UNC Workgroup Report		At what stage is this document in the process?
<h1>UNC 0607S:</h1> <h2>Amendment to Gas Quality NTS Entry Specification at the St Fergus NSMP System Entry Point</h2>		<div style="display: flex; flex-direction: column; gap: 5px;"> <div style="border: 1px solid #ccc; padding: 2px; display: flex; align-items: center; gap: 5px;">01 Modification</div> <div style="border: 1px solid #ccc; padding: 2px; display: flex; align-items: center; gap: 5px;">02 Workgroup Report</div> <div style="border: 1px solid #ccc; padding: 2px; display: flex; align-items: center; gap: 5px;">03 Draft Modification Report</div> <div style="border: 1px solid #ccc; padding: 2px; display: flex; align-items: center; gap: 5px;">04 Final Modification Report</div> </div>
<p>Purpose of Modification:</p> <p>This enabling modification will facilitate a change to the current contractual Carbon Dioxide limit at the St Fergus NSMP System Entry Point, through modification of a Network Entry Provision contained within the Network Entry Agreement (NEA) between National Grid Gas plc and North Sea Midstream Partners Limited (NSMP) in respect of the St Fergus NSMP Sub Terminal.</p>

This is an enabling modific

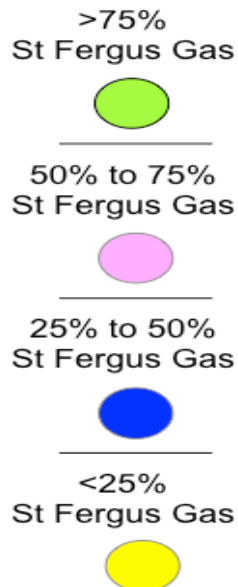
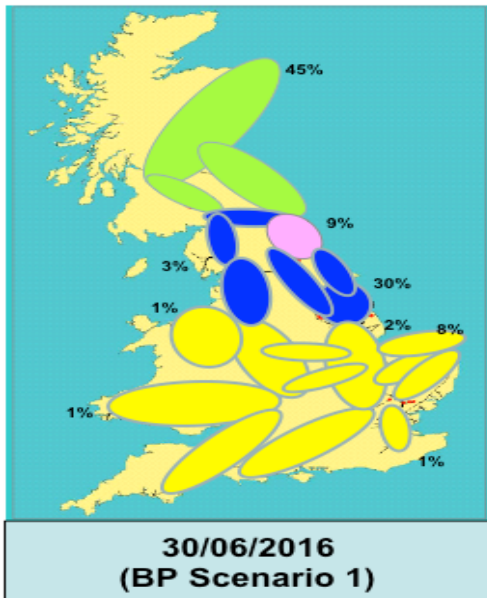
The Workgroup asked National Grid NTS to provide a view on the analysis performed by BP and they used the inputs to the four BP scenarios and calculated the CO₂ content that would be expected on

the pipelines leaving St Fergus terminal. The results below demonstrate that National Grid NTS' calculations align well with the analysis performed by BP. (Note the figure of 172 mscm/d relates to total national demand)

30th June 2016 (172mscm/d)							
Scenario 1		Scenario 2		Scenario 3		Scenario 4	
BP Results	NG Results	BP Results	NG Results	BP Results	NG Results	BP Results	NG Results
3.65	3.65	3.78	3.79	3.66	3.66	3.87	3.88

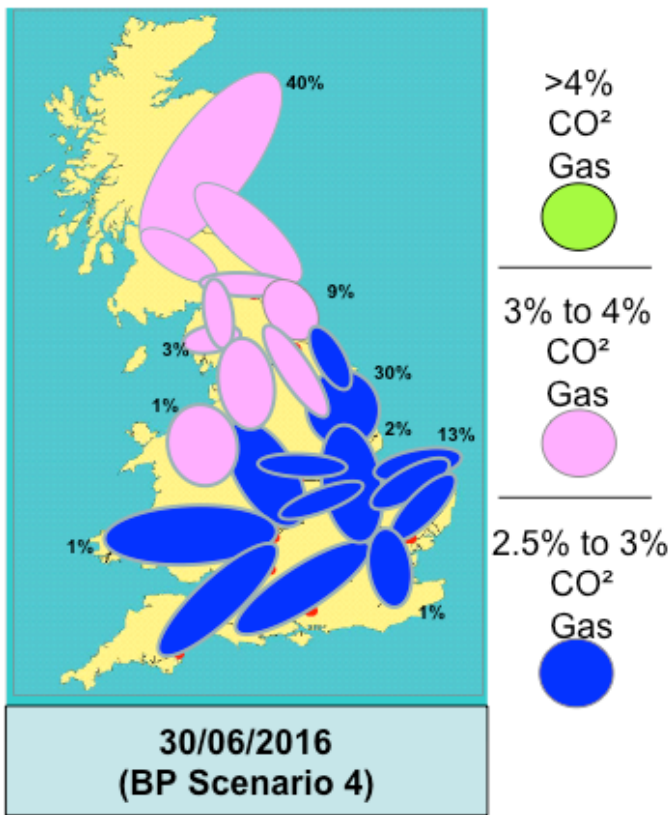
In respect of the BP scenarios National Grid NTS were also asked to provide a 'heat map' analysis; to determine the risk of high CO₂ gas entering the NTS and how far any out of specification flow might then be expected to reach. The Workgroup also requested that the analysis contained information about the assumed distribution of supplies, where the gas would blend on the NTS and the NTS flow patterns.

Comment [C4]: To be updated to include the weighted average CO₂ positions and the maximum daily CO₂ levels.

The second 'heat map' schematic shows the levels of CO₂ on the NTS, assuming St Fergus sub-terminal flows and CO₂ content are equal to BP's scenario 4 (giving a 'worst case' CO₂ entering the NTS from the four BP scenarios). This scenario shows a blend of 3.87% CO₂ entering the NTS, therefore no NTS direct connect receives any gas in excess of 4%.

Supplies from other NTS entry points are proportionate to the 2016 FES for that demand level and deliver gas at their CO₂ limits. The percentages show the contribution to total demand from each supply source.

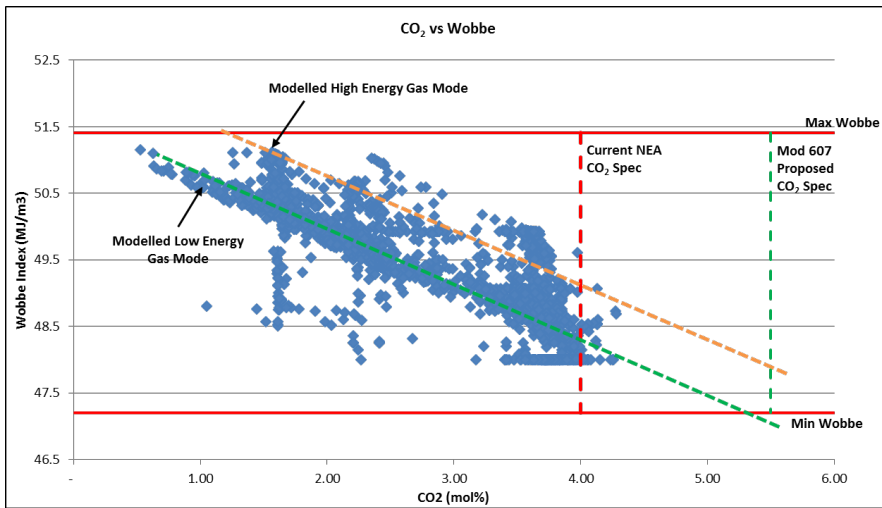
The Workgroup sought input from NSMP to improve their understanding of how the plant operates at the right Wobbe Index level and the effect on the CO₂ levels/liquids.

The composition of export gas from St Fergus is monitored by the control room and procedures are in place to ensure the specification of export gas is maintained. NSMP is fully aware of the composition of commingled pipeline gas upstream of the terminal and therefore would be aware of higher CO₂ concentrations in FUKA pipeline gas well before such gas reaches the terminal (as they are today). If NSMP's pipeline operating model suggested that by processing such gas, the lower specification for Wobbe Index might be breached, NSMP would modify the operating conditions at the terminal (specifically levels of NGL extraction) to ensure that the specification for export gas is met. This can be done relatively quickly and well within the anticipated transit time of any high CO₂ gas present within the pipeline.

To answer the questions relating to CO₂ concentrations in liquids export and maintaining water dew point, NSMP has run a number of HYSYS simulations with gas compositions up to 6 mol% CO₂ and can confirm that at higher concentrations of CO₂ within the pipeline gas, the CO₂ content of the NGL does increase. However in all modes of operation required to maintain the NTS gas specifications, the CO₂ content of the NGL remains less than 0.001 mol% which is well below the specification limits for NSMP's NGL export. In theory, there is some impact on the water dewpoint of export gas through increased CO₂ content however, this is taken care of by the gas dehydration system and in all cases modelled, the sales gas remains well within spec (by a margin of over 40°C).
